ADDENDUM NUMBER ONE (1)
CATAWBA COUNTY
BLACKBURN RESOURCE RECOVERY FACILITY OPERATOR'S BUILDING
PROJECT NO. 26.00701

This Addendum Number One (1) is issued this the 14th day of October 2026, to all parties who hold a set of Bid Documents for the project entitled: **“BLACKBURN RESOURCE RECOVERY FACILITY OPERATOR'S BUILDING”**. This Addendum Number One (1) shall become part of the Contract Documents and its receipt acknowledged on the bid documents at the time of bidding.

5 VENTED RIDGE CAP
1 1/2" = 1'-0"

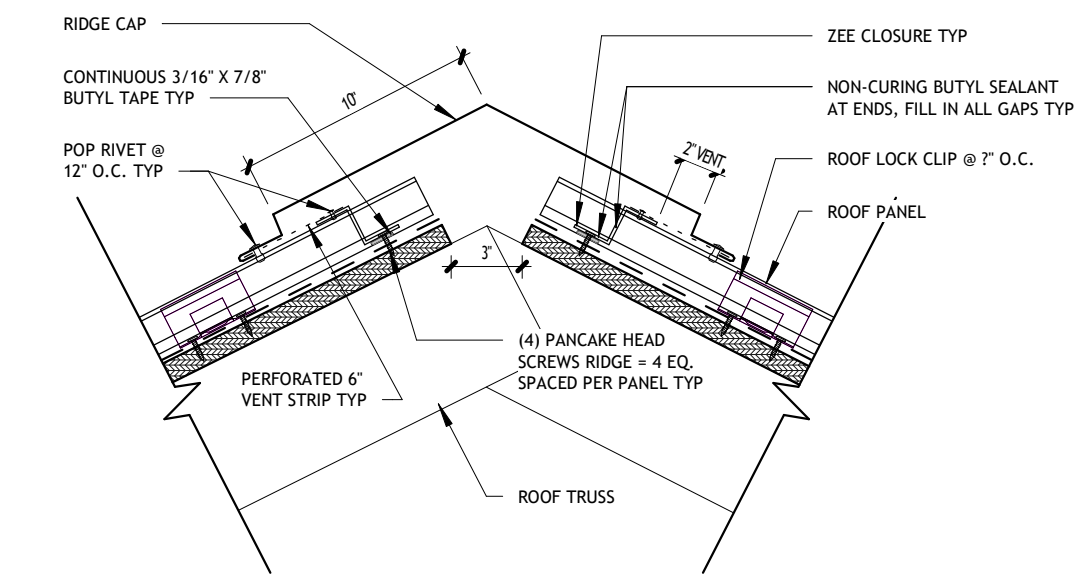
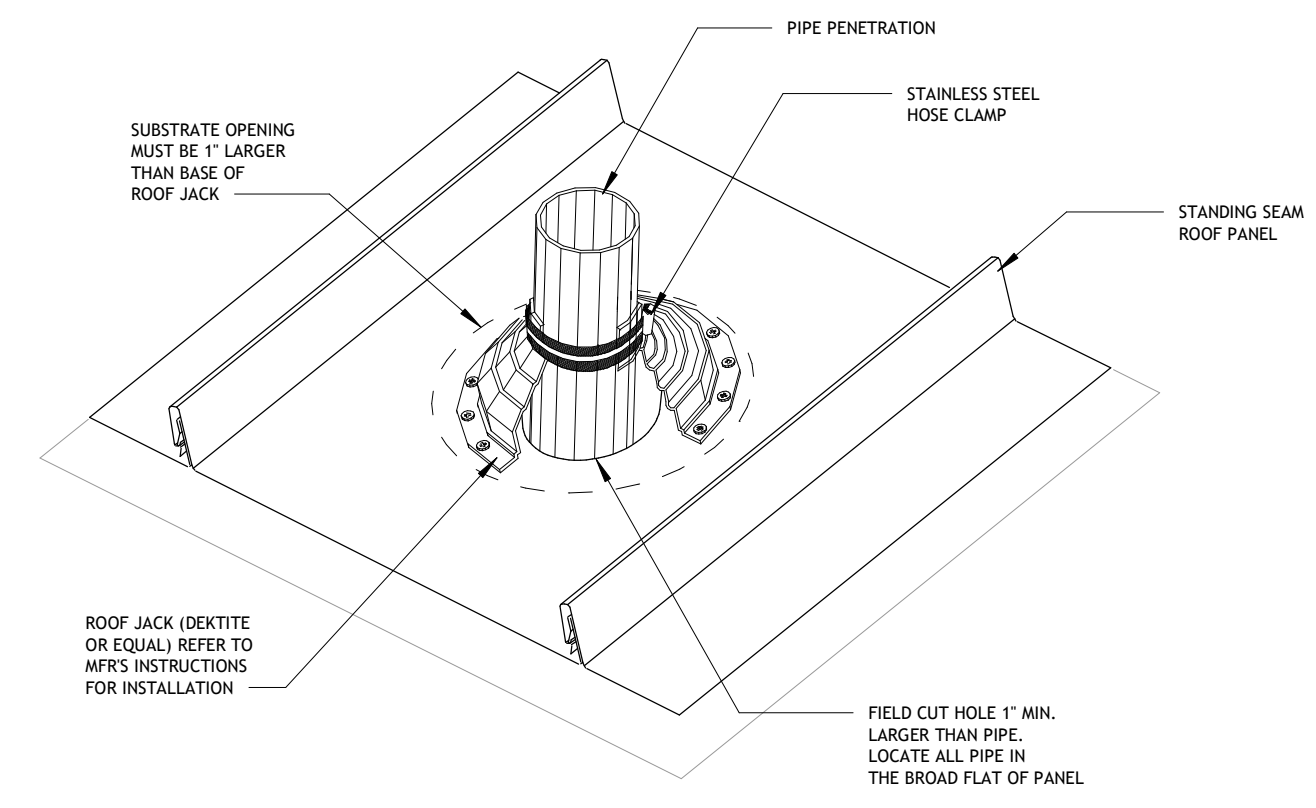
1. Drawings: The below information includes changes, revisions, and updates to the drawings from the original bid set. Please replace the following sheets.
 - a. *Sheet A110*: Revisions made to gutter system and attic insulation types.
 - b. *Sheet A201*: Revisions to gutter system.
 - c. *Sheet A301*: Revisions made to attic insulation type.
 - d. *Sheet A310*: Revisions to gutter system and inclusion of ice and water shield.

- *Could standard commercial gutters be substituted for the 8" round design?*

- *Will the insulation be blown cellulose or batt insulation in the attic?*

- *Are snow guards required?*

6" Commercial box gutters are acceptable. Please see revisions to sheets A110, A201 & A310.

Attic insulation to be batt. Please see revised sheets A110 & A301 in Addendum No. 1.

Yes, snow guards are required for the standing seam metal roof. Please see revised sheet A110 with added notes on snow guard requirements.

SHEET NO.
A201

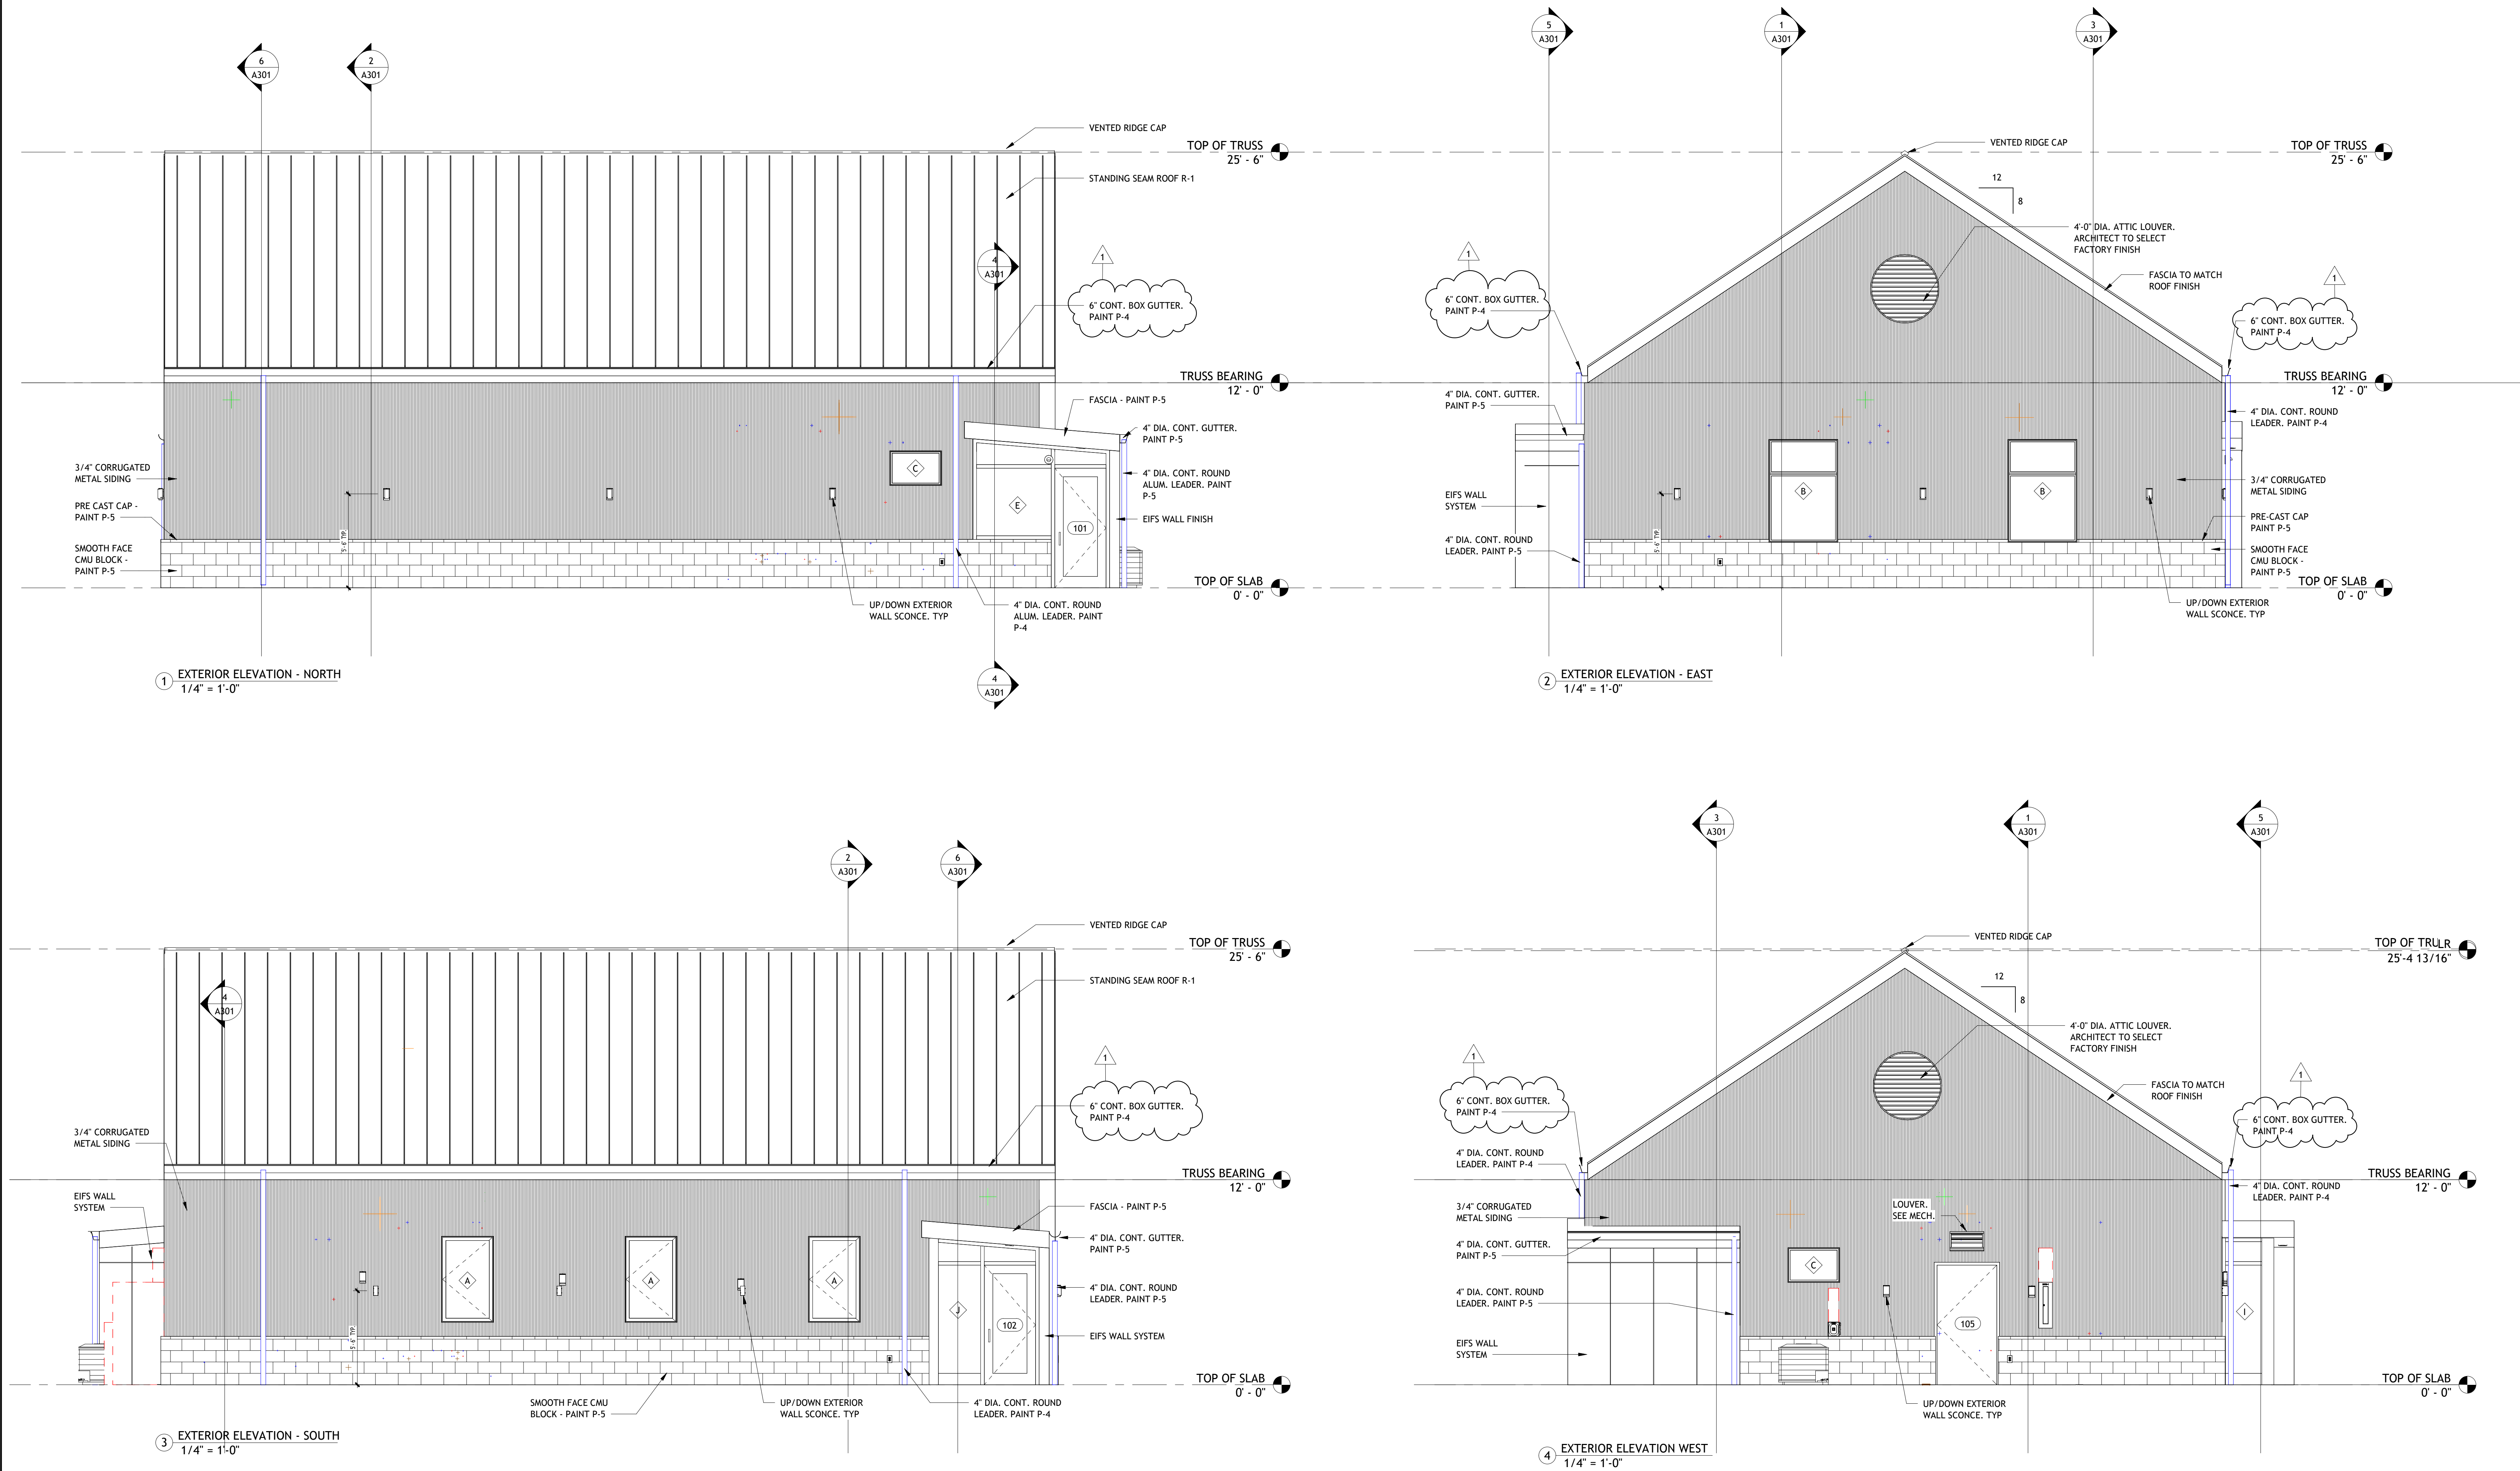
- *Can clarification be provided for the gutter details on A201 and A310?*

Please see revisions to sheets A110, A201 & A310 Addendum No. 1.
